# Access Compliance Report

## Public Rights-of-Way

### (Curb Ramps)

Intersection ID: 31338	Main Street: ALEXANDER_POINTE_DR	Cross Street: W_MALLARD_CREEK_CHURCH_RD	Location: N
ADA ID: A43377E3CBF8	Ramp Type: Perp	Initial Pass/Fail: Fail	Overall Compliance: No
		Severity Score: 12.5

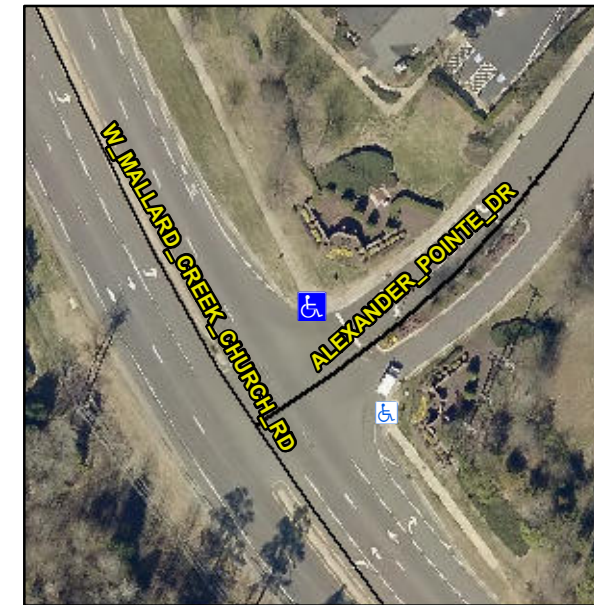
**R304.2.2**

Compliance	Description	Data	Compliance	Description	Data
N/A	Ramp Length (in)	60.0	No	Ramp Slope (%)	9.9
Yes	Ramp Width (in)	48.5	Yes	Ramp XSlope (%)	0.5
N/A	Flare Type LT	N/A	N/A	Flare Type RT	N/A
N/A	Flare Slope LT (%)	N/A	N/A	Flare Slope RT (%)	N/A
N/A	Flare Traversable LT?	N/A	N/A	Flare Traversable RT?	N/A
N/A	Landing Length (in)	N/A	N/A	DWS Provided?	N/A
N/A	Landing Width (in)	N/A	N/A	DWS Contrast?	N/A
N/A	Landing Slope (%)	N/A	N/A	DWS Length (in)	N/A
N/A	Landing X Slope (%)	N/A	N/A	DWS Full Width?	N/A
N/A	Landing Curb? (Y/N)	N/A	N/A	DWS Offset (in)	N/A
N/A	Shared Landing?	N/A			
N/A	Gutter Ponding?	N/A	N/A	Gutter Slope (%)	N/A
N/A	Gutter Lip Ht (in)	N/A	N/A	Gutter X Slope (%)	N/A
N/A	Painted X Walk1?	No	N/A	Painted X Walk2?	N/A
	X Walk 1 Direction	To SE		X Walk 2 Direction	N/A
N/A	X Walk 1 Width (in)	N/A	N/A	X Walk 2 Width (in)	N/A
	X Walk 1 Slope (%)	2.8		X Walk 2 Slope (%)	N/A
	X Walk 1 X Slope (%)	2.9		X Walk 2 X Slope (%)	N/A

**Remove & Replace Entire Ramp.**
